HOPE CREEK GENERATING STATION
DOCKET NO. 50-354
DRAFT SAFETY EVALUATION REPORT
OPEN ITEMS

Pursuant to your letter dated March 5, 1984, which transmitted the Hope Creek Draft Safety Evaluation Report (SER), enclosed for your review and approval (see Attachment 2) are the resolutions to those Draft SER open items listed in Attachment 1.

FIGURE 4.6-10

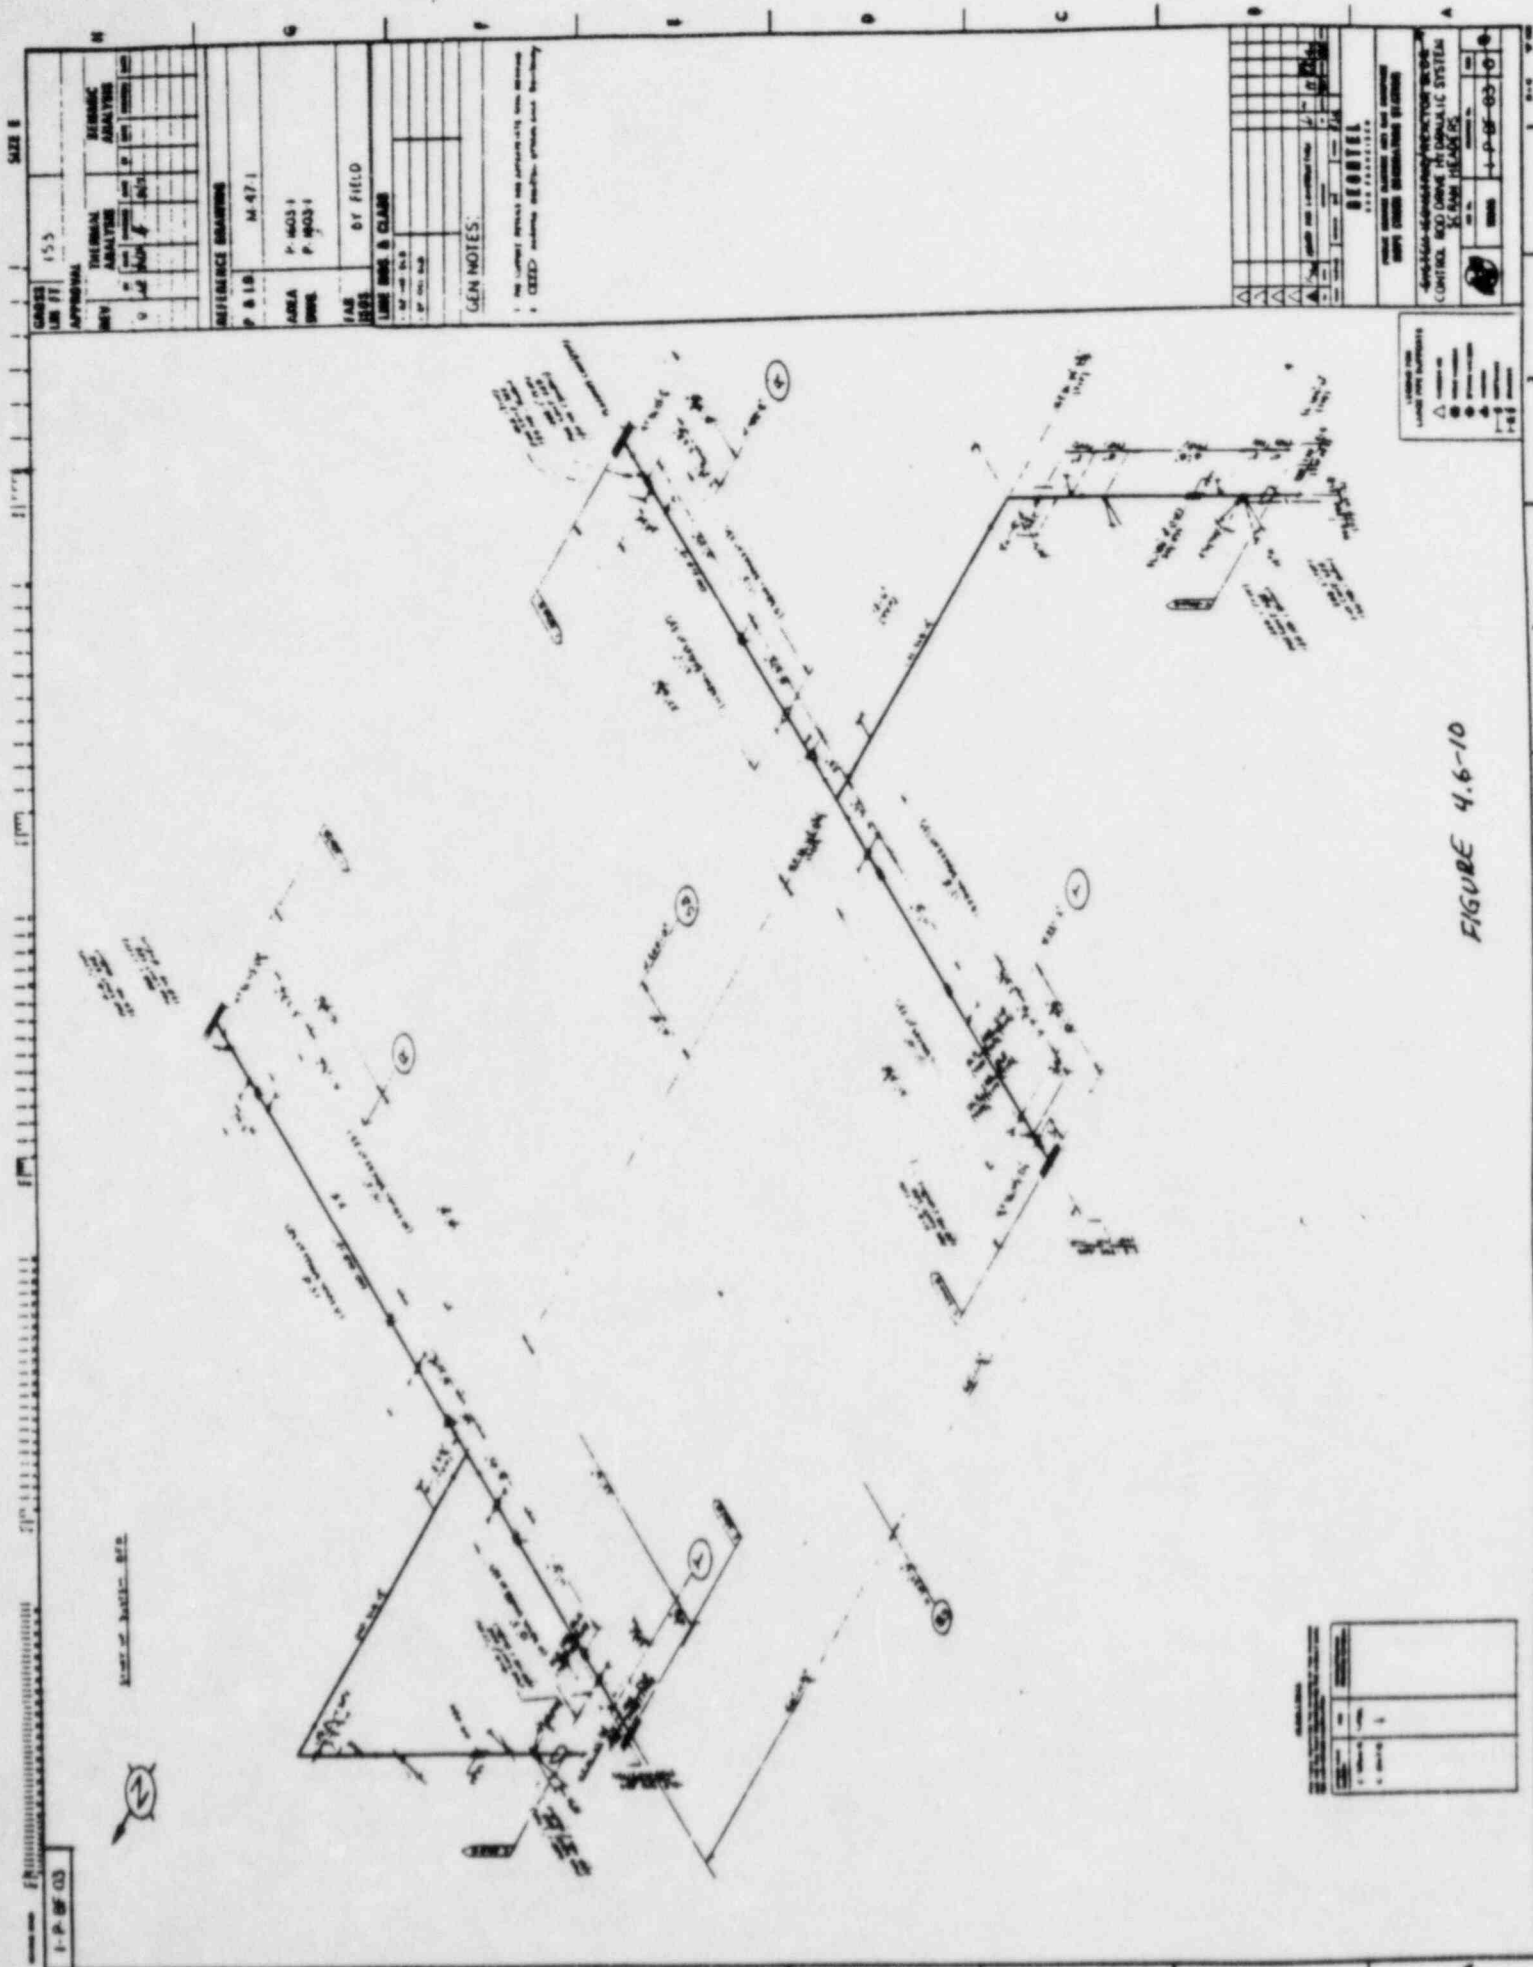
The header piping slopes to a low point with a minimum pitch of 1/8 inch per foot as shown on Figure 4.6-10.

GENERAL ARRANGEMENT
SECTION C & D

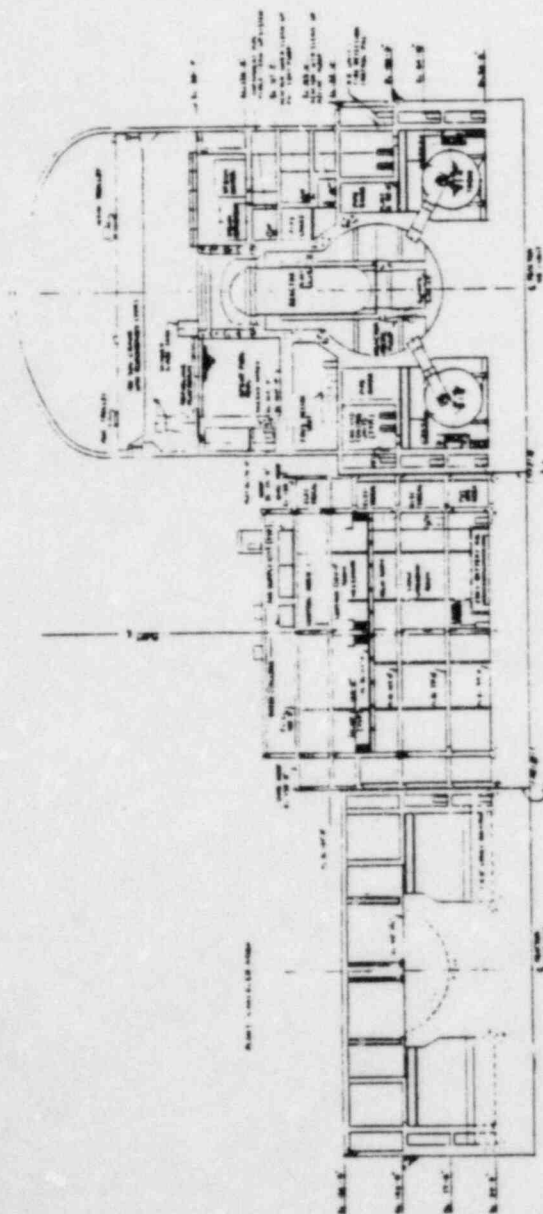
The ECCS suction strainers are located above the bottom of the torus in eight different sections. Figures 2-1 through 2-5 show the general arrangement.

FIGURE 3-1

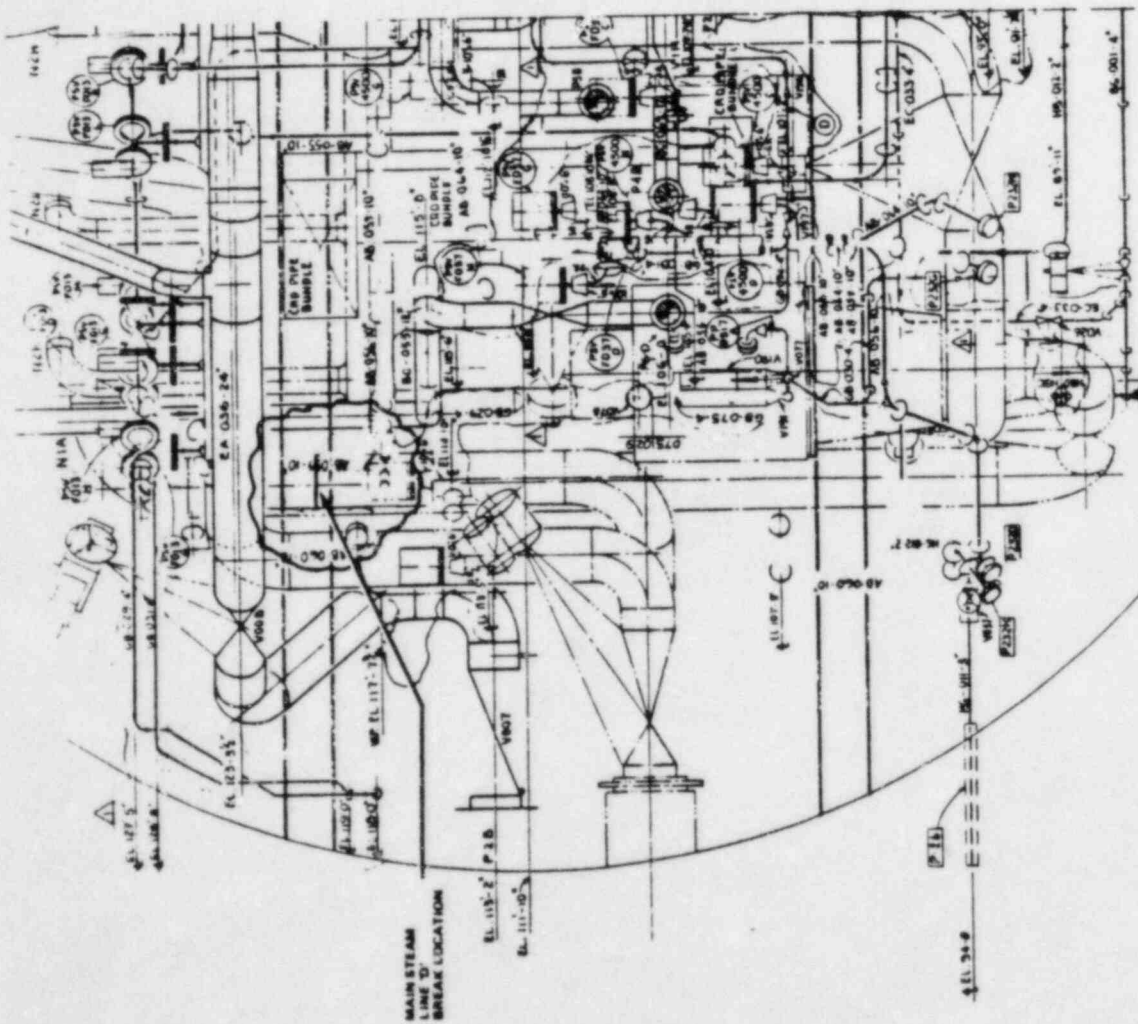
3.4.1 The volume of insulation debris that will accumulate on each strainer is calculated. Each pump has a separate suction line with a strainer located in the torus as shown on figure 3-1. The design and dimensions of the strainers is shown in figure 3-2. The effective surface area for each LPCI strainer is 15.2 ft². The effective surface area for each core spray strainer is 5.64 ft². The total ECCS strainer area is 83.4 ft².
